mercruiser
STERN DRIVES & INBOARDS

service bulletin

No. 92-11

A. TESTING THUNDERBOLT IV HEI IGNITION SYSTEM

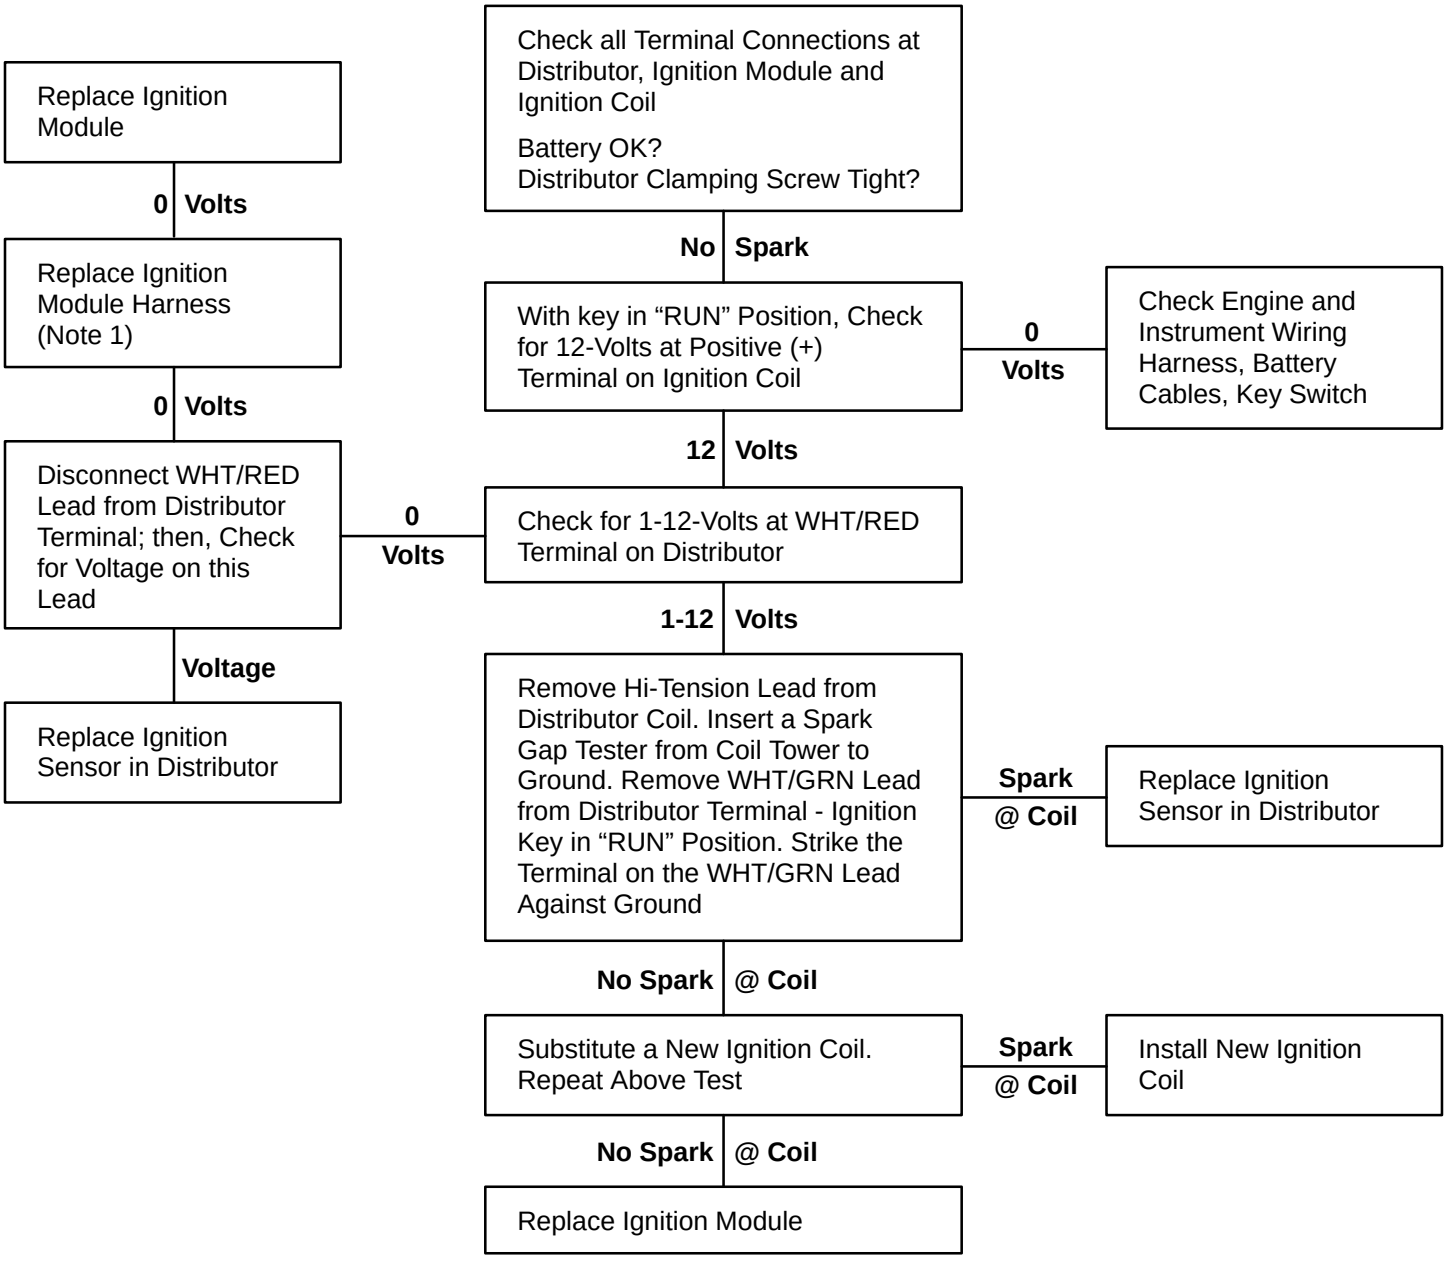
This latest test diagram will be added to all Service Manuals at their next update. Use a voltmeter when making these tests. Do not use a test light.

NOTE 1: Early, large ignition modules did not have a replaceable wiring harness.
